APPLICATION NO.	FILING DATE	FIRST NAMED INVENTOR	ATTORNEY DOCKET NO.	CONFIRMATION NO.
10/812,011	03/30/2004	Jeong-su Lim	1572.1274	2786
21171	7590	05/16/2008		
STAAS & HALSEY LLP SUITE 700 1201 NEW YORK AVENUE, N.W. WASHINGTON, DC 20005			EXAMINER EPPS, TODD MICHAEL	
			ART UNIT 3632	PAPER NUMBER
			MAIL DATE 05/16/2008	DELIVERY MODE PAPER

### Office Action Summary

This is the third Office Action **final** for serial number 10/812,011, Monitor Apparatus, filed on March 30, 2004.

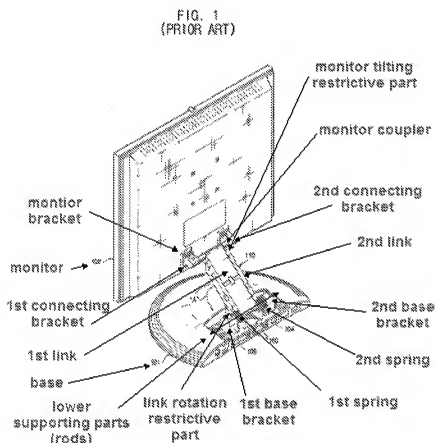
Claims 1-4, 6, 13, and 38 are rejected under 35 U.S.C. 102(b) as being anticipated by the Applicants Admitted Prior Art (AAPA) as identified by Fig. 1-2b of the drawings, and pages 1-2 of specification, which the applicant submitted.

The prior art discloses a first link (110, interior) provided between the monitor (102) and the base (101); a second link (110, exterior with H-shape portion) provided between the monitor (102) and the base (101), and adjacent to the first link; wherein the second link is provided as a pair (110, 2<sup>nd</sup> side - top portion and side portion) and formed to be bar-shaped; a base bracket (104, and 106), combined to the base (101),

the base bracket having first and second lower supporting parts (adjacent of 104, and 106) to rotatably support lower parts of the first and second links, respectively; a connecting bracket (fig. 1) rotatably combined to the monitor (102), the connecting bracket having first and second upper supporters (fig. 1) to rotatably support upper parts of the first and second links, respectively; a first spring (fig. 1- 1<sup>st</sup> side) interposed between the first link and the first lower supporting part, to elastically bias the first link upward with respect to the base; wherein the first spring comprises a torsion spring having a first end coupled to the first lower supporting part, and a second end coupled to the first link; wherein the monitor is tilted with respect to the connecting bracket to adjust a tilting angle of the monitor; a second spring (fig. 1- 2<sup>nd</sup> side) interposed between the second link and the second lower supporting part to elastically bias the second link upward with respect to the base, wherein the distance between rotating axes of the first and second lower supporting parts that rotatably support the first and second links, respectively, is greater than the distance between tilting axes of the first and second upper supporters; a monitor coupler (fig. 1) spaced from the first and second supporters, and rotatably combined to the monitor; a link rotation restrictive part (fig. 1; bottom between springs and links) to restrict a rotation angle of at least one of the first and second links relative to the base; wherein the link rotation restrictive part further comprises a protrusion protruding from the base bracket to restrict the rotation angle of at least one of the first and second links by making contact with an upper surface of at least one of the first and second links (fig. 1); wherein the second spring further comprises a torsion spring having a first end removably coupled to the second lower

supporting part, and a second end removably coupled to the second link; a monitor bracket (fig. 1 - backside of the monitor) combined to the monitor, and rotatably combined to the connecting bracket.

In response to applicant's argument that the connecting member 110 is one single link and therefore does not anticipate a separately recited first link and second link. The Examiner respectfully disagrees. Although, the applicant labeled the connecting member 110 as one element, but within the element, there are two parts connected together as one element. Applicant will see the annotated copy of figure 1 above that there are parts: a H-shaped connecting member (2<sup>nd</sup> link) and a central

connecting member (1<sup>st</sup> link); and the central connecting member which is mounted in between the H-shaped connecting member with first and second axes that go through the apertures at lower and upper ends to hold them together as one element (110). Therefore, this meets the limitation of the independent claims 1, 16, and 41.

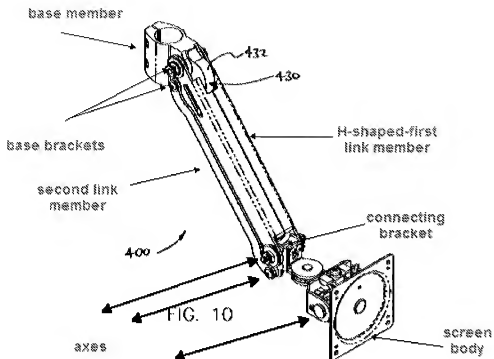
Claims 44-47, and 49 are rejected under 35 U.S.C. 102(e) as being anticipated by U.S. Patent No. 7,252,277 to Sweere et al. (Sweere).

Sweere '277 discloses a display apparatus (figure 10) comprising: a screen body; a base member supporting the screen body; a first link member provided between the screen body and the base member, the first link member being rotatable with respect to the screen body at an upper end and being rotatable with respect to the base member at a lower end; a second link member provided between the screen body and the base member, the second link member being rotatable with respect to the screen body at an upper end and being rotatable with respect to the base member at a lower end; a base bracket coupling the base member with the lower end of the first link member and the lower end of the second link member; a connecting bracket coupling the screen body with the upper end of the first link member and the upper end of the second link member; wherein the first link member and the second link member have a different axis of rotation at the upper ends and the lower ends; wherein the screen body is rotatable with respect to the connecting bracket; wherein the screen body have a different axis of rotation from the upper ends of the first link member and the second link member; wherein the axes of rotation of the screen body and the upper ends of the first member and the second link member are parallel apart from one another; and wherein the first link member has an H-shape.

Claim 48 is rejected under 35 U.S.C. 103(a) as being unpatentable over Sweere '277.

Sweere '277 fails to disclose wherein the distance between axes of rotation of the lower ends of the first and second link members is greater than the distance

between the axes of rotation of the upper ends of the first and second link members.

Although, Sweere '277 discloses wherein the distance between axes of rotation of the lower ends of the first and second link members is the same as the distance between the axes of rotation of the upper ends of the first and second link members.

Accordingly, it would have been obvious to one of ordinary skill in the art at the time the invention was made to have modified the links of Sweere '277 to include the distance between the links at one lower end to be greater because one would have motivated to provide a design consideration which fails to patentably distinguish over the prior art reference of Sweere '277. Furthermore, it is a functional equivalent whether the distance as stated above are the same or greater over the other as long as it can rotate and support a monitor.
